SUNDRY NOTICES AND REPORTS ON WELLS

1. OIL WELL ☒ GAS WELL ☐ OTHER ☐		SEP 30 1980		5. LEASE DESIGNATION AND SERIAL NO. RM 12141	
2. NAME OF OPERATOR Coronado Exploration Corp.		O. C. D.		6. IF INDIAN, ALLOTTEE OR TRIBE NAME	
3. ADDRESS OF OPERATOR 1005 Marquette NW, Albuquerque, NM 87102		ARTESIA, OFFICE		7. UNIT AGREEMENT NAME	
4. LOCATION OF WELL (Report location clearly and in accordance with any State requirements.* See also space 17 below.) At surface 660 FWL & 660 FWL				8. FARM OR LEASE NAME Martinez Federal	
				9. WELL NO. 1	
				10. FIELD AND POOL, OR WILDCAT Wildcat	
				11. SEC., T., R., M., OR BLK. AND SURVEY OR AREA Sec. 22 6N 17E	
14. PERMIT NO.		15. ELEVATIONS (Show whether DF, RT, GR, etc.) 5690.73 Gr.		12. COUNTY OR PARISH Guadalupe	
				13. STATE NM

Exhibit A

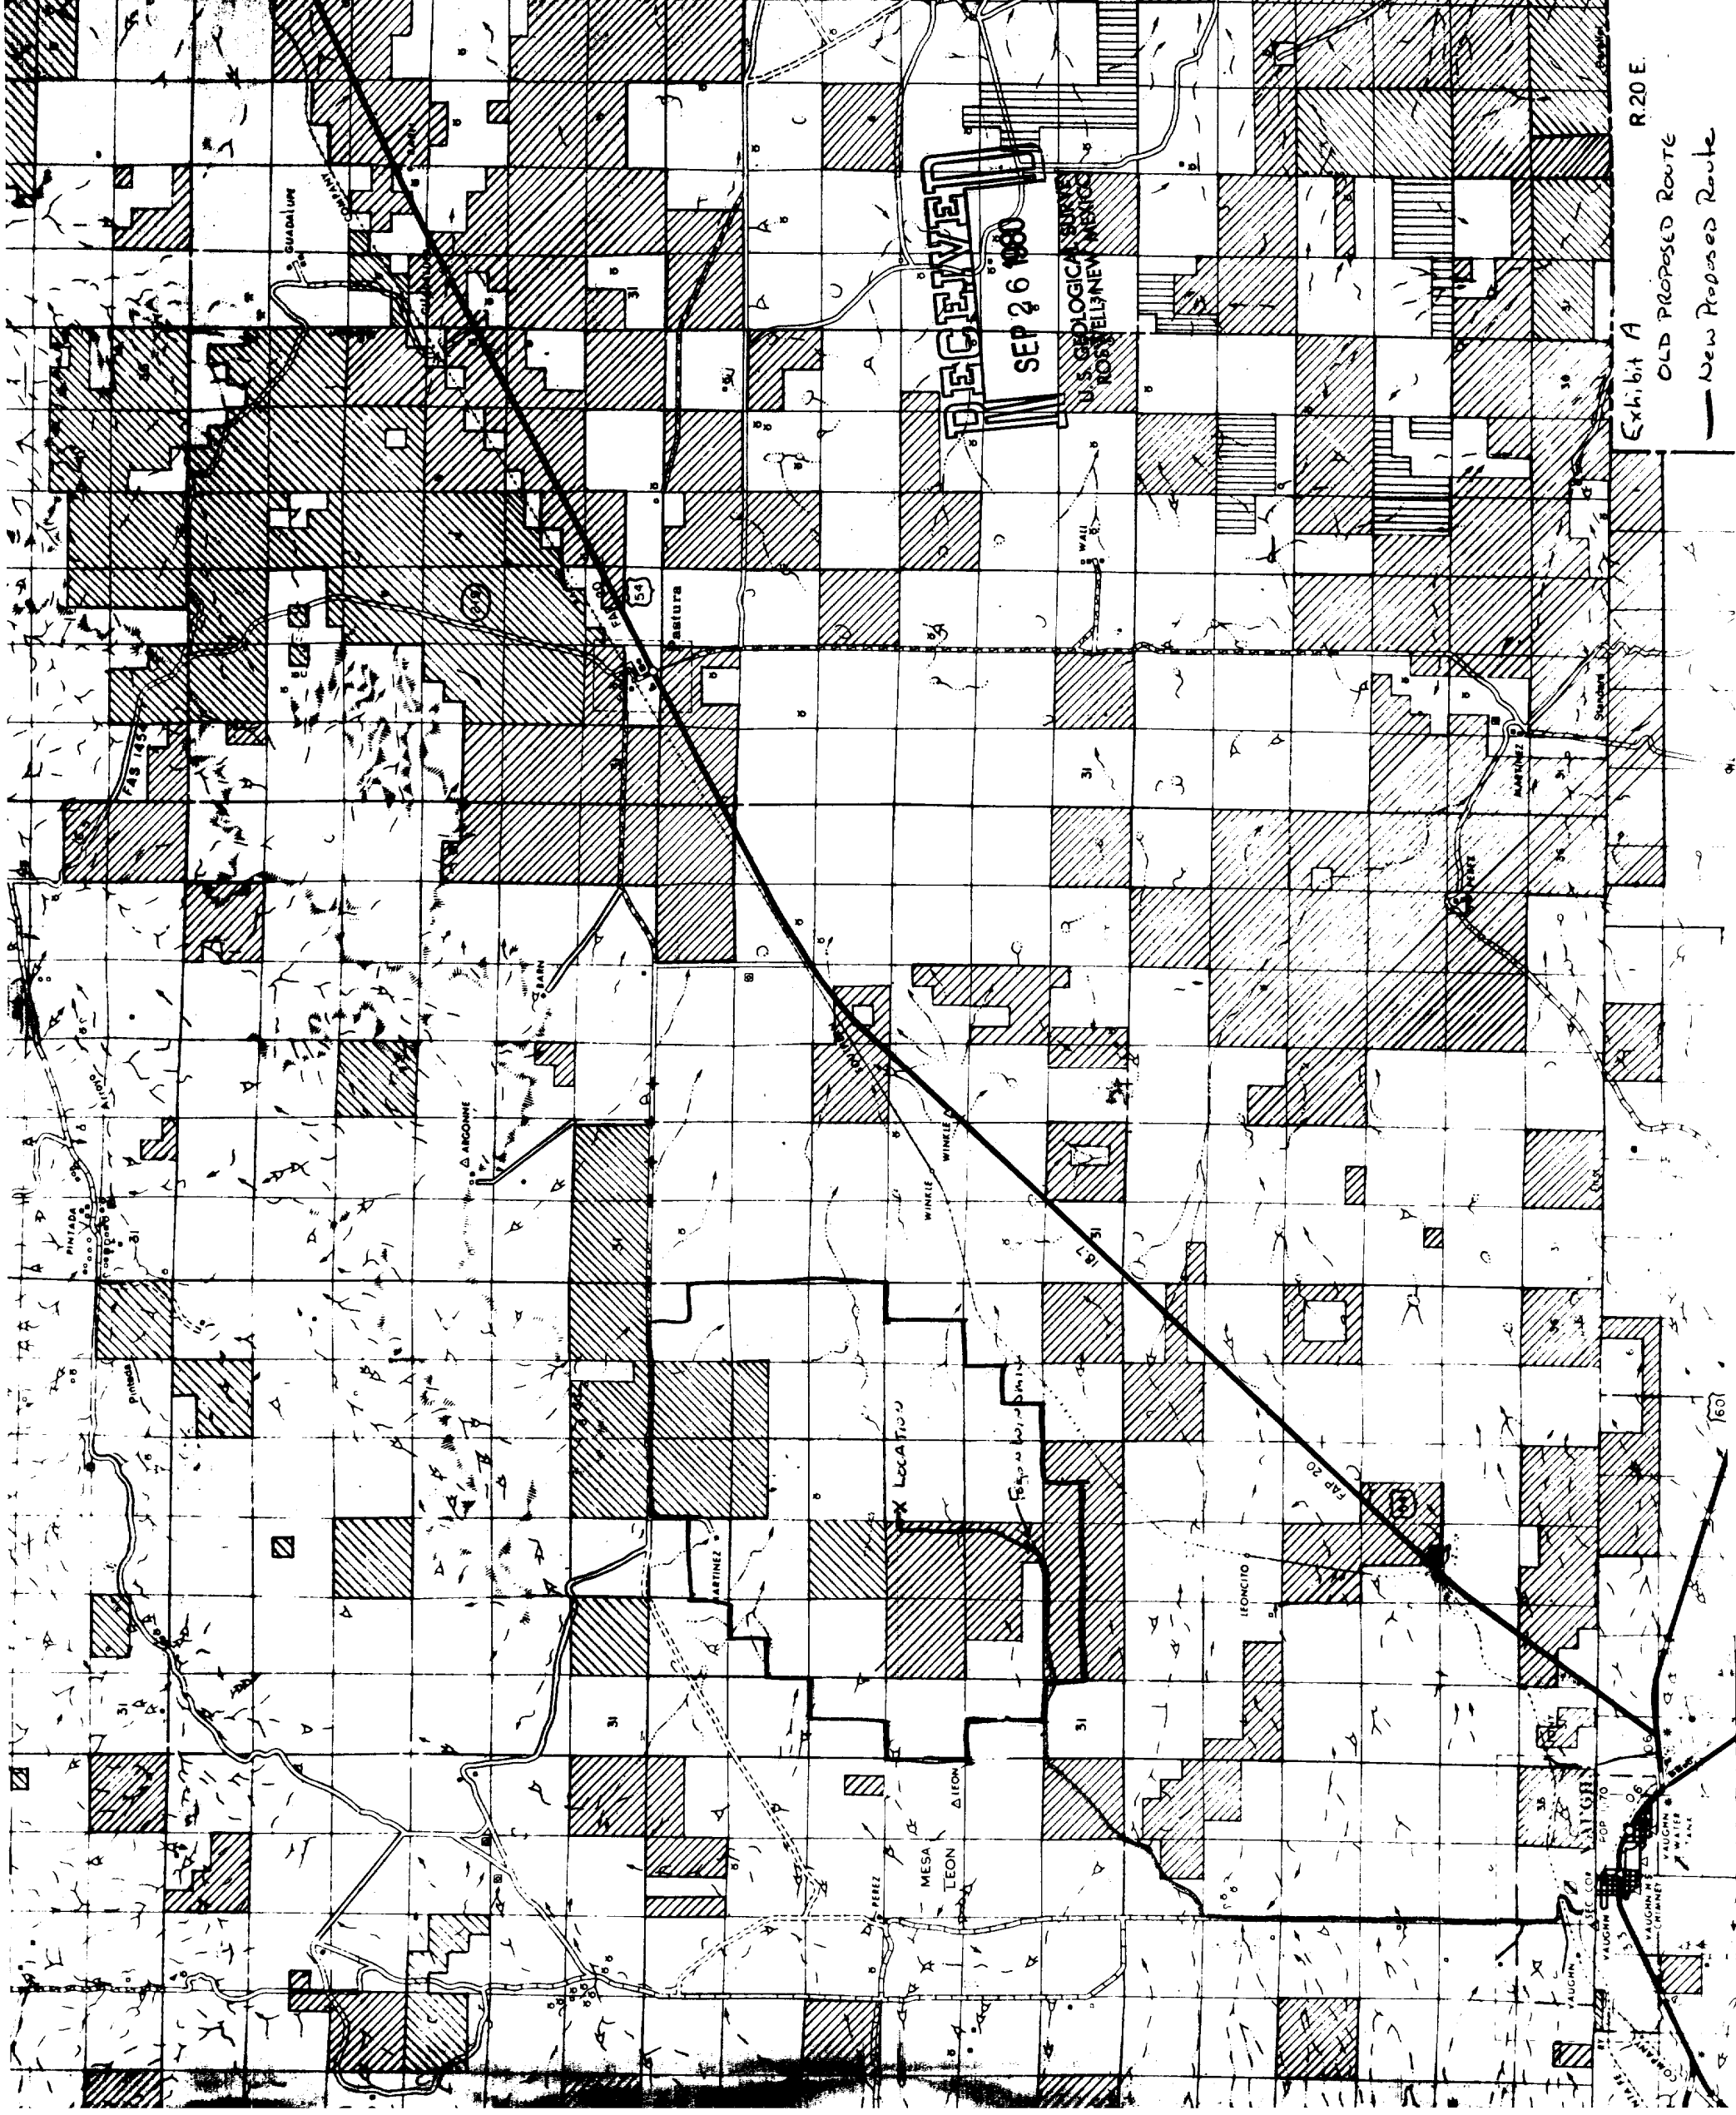
Amend route of entry to well

See exhibit "A"

OLD PROPOSED ROUTE

New Proposed Route
